Brink Zone Reliability Improvements, Mandatory Referral, MR2017006

**Brink Zone Reliability Improvements: MR2017006**

**Staff Recommendation: Approval with Comments**

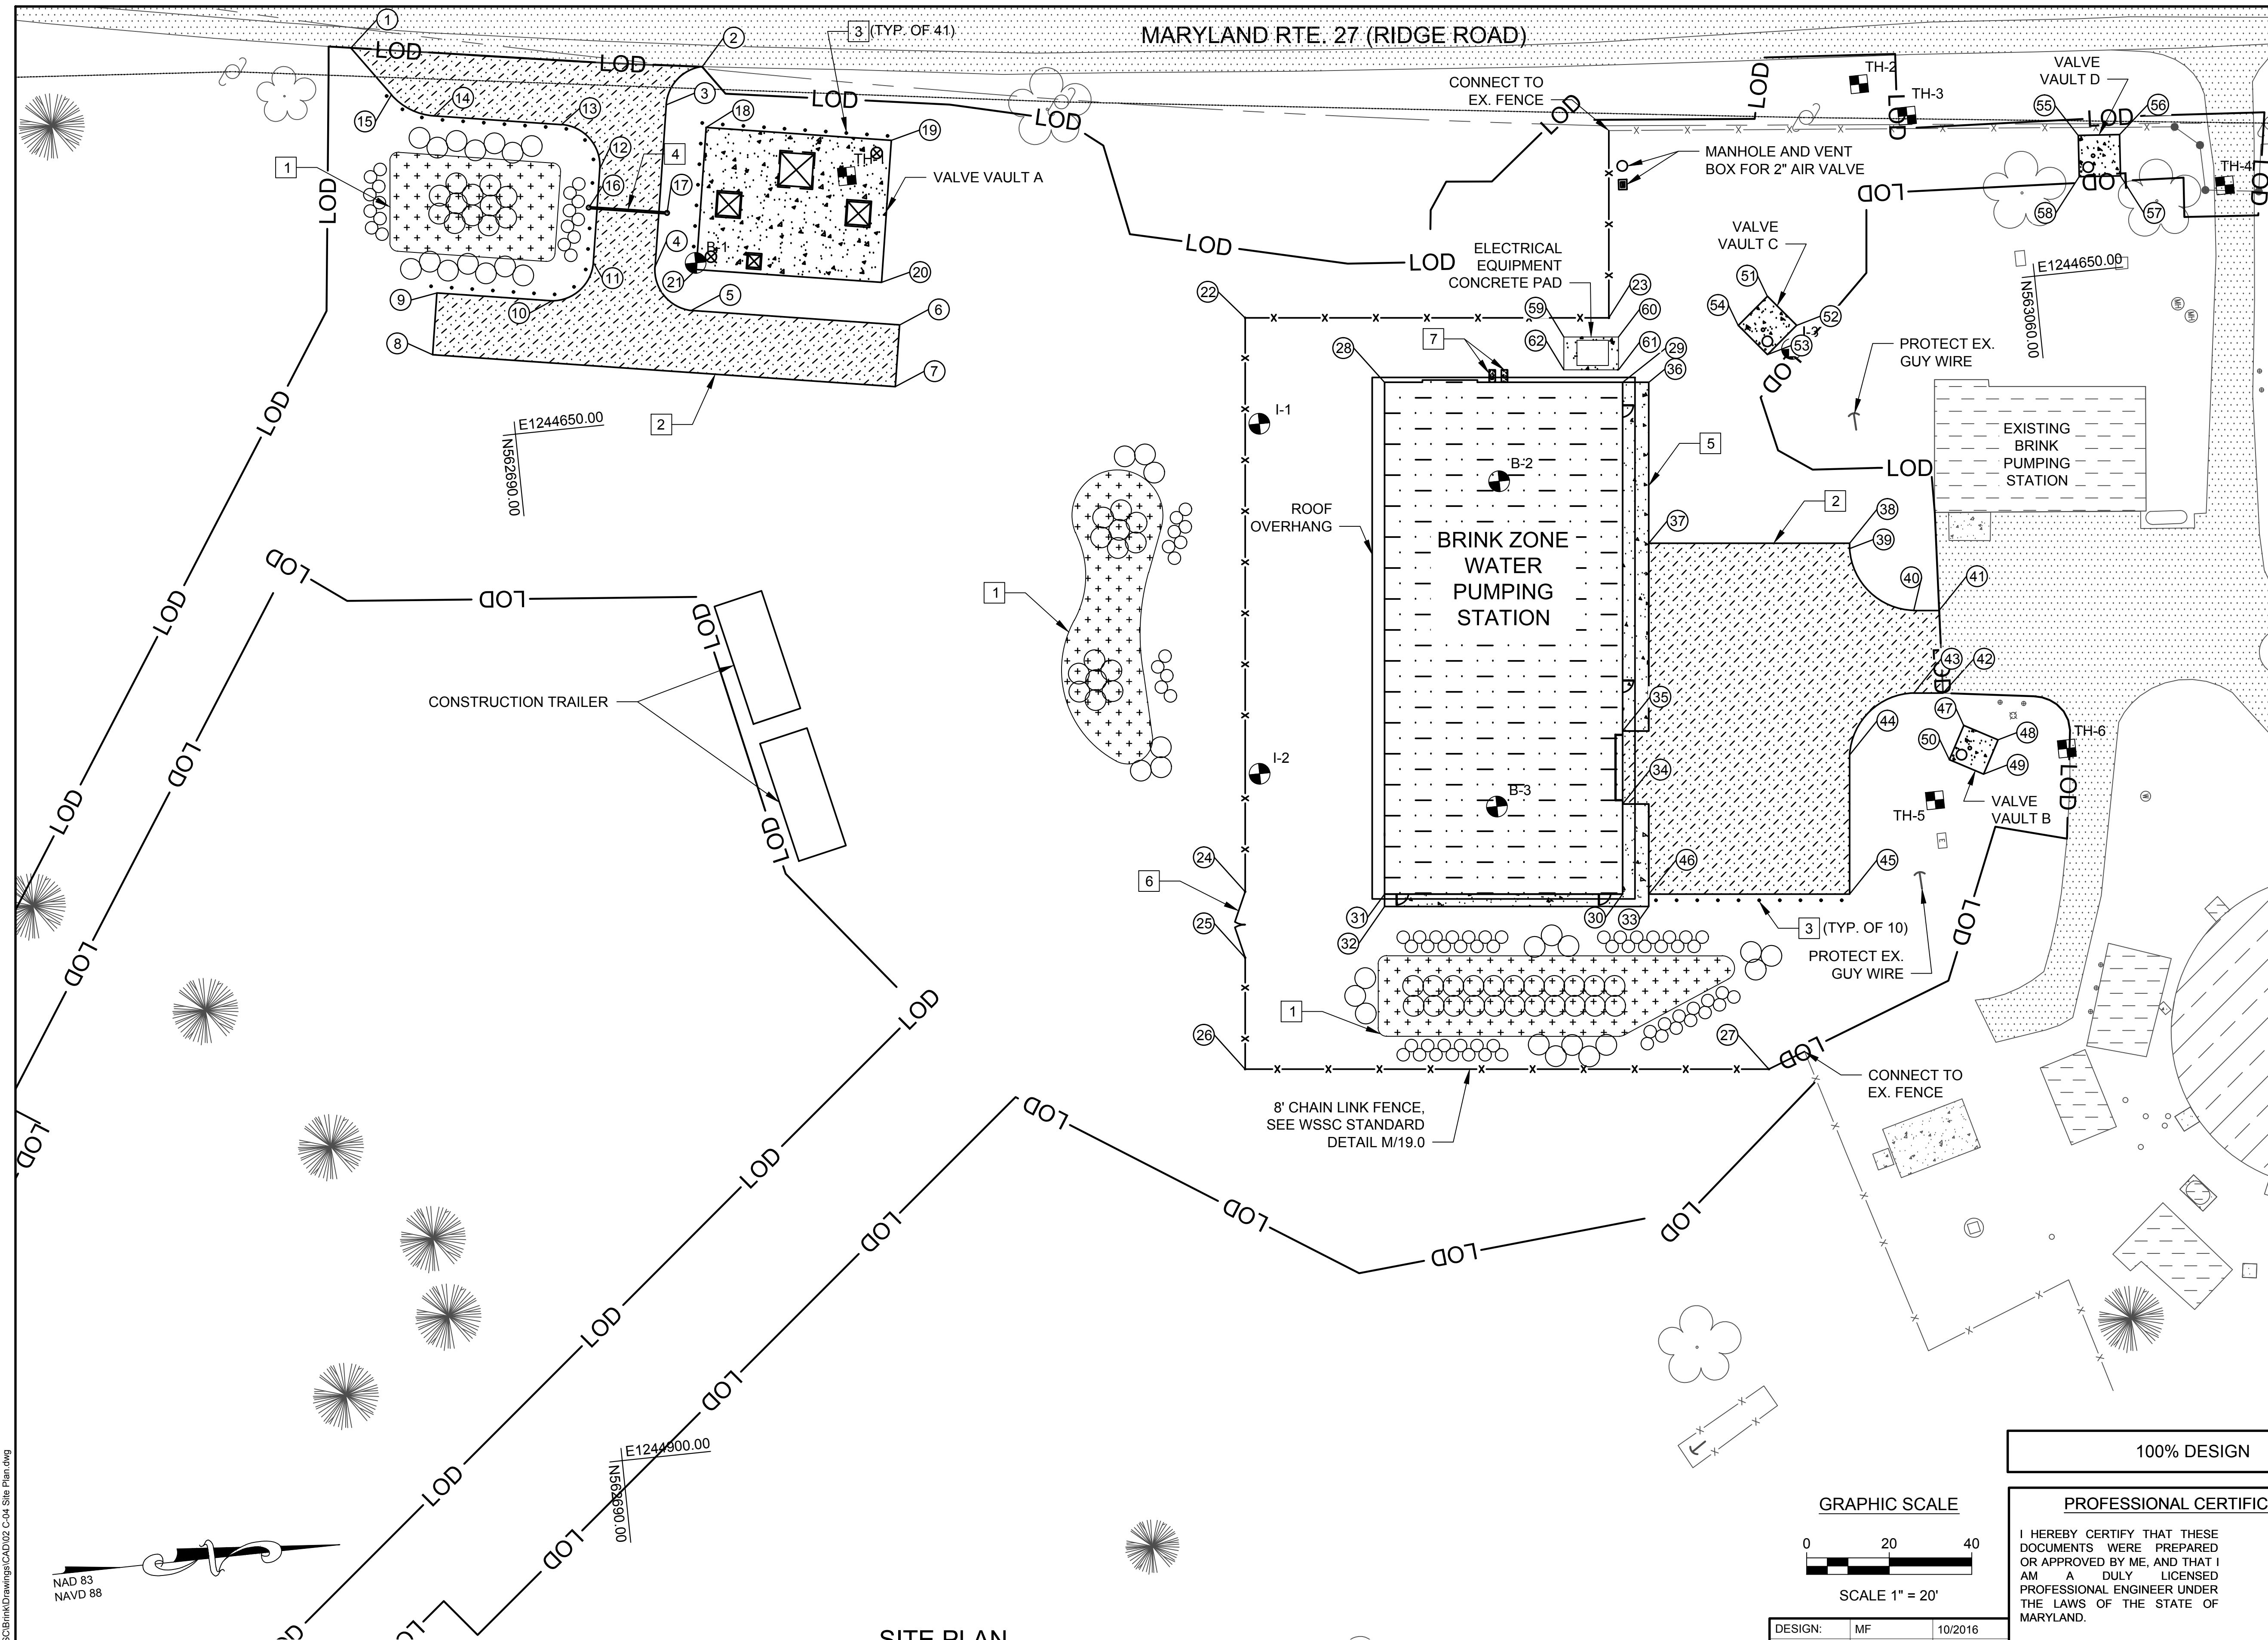
1. The current Mandatory Referral Plan shows the vault chamber (valve vault A) within the Master Plan right-of-way for Ridge Road. Therefore, Planning staff recommends WSSC move the vault chamber outside of the 150-foot right-of-way planned along Ridge Road to ensure that future conflicts between transportation infrastructure and WSSC facilities do not occur.

4. Coordinate with Maryland State Highway Administration (SHA) District 3 Access Management staff on the additional curb cut and any potential acceleration or deceleration lanes on Ridge Road. Planning staff would prefer that the applicant use the existing curb cut for the new valve vault to minimize access points on Ridge Road if possible.

5. Ensure adequate turning radii from Ridge Road and within the property for the diesel fuel delivery trucks that will service the project site during extended power outages. Additionally, ensure adequate pavement and substructure to accommodate the weight of such vehicles on the property.
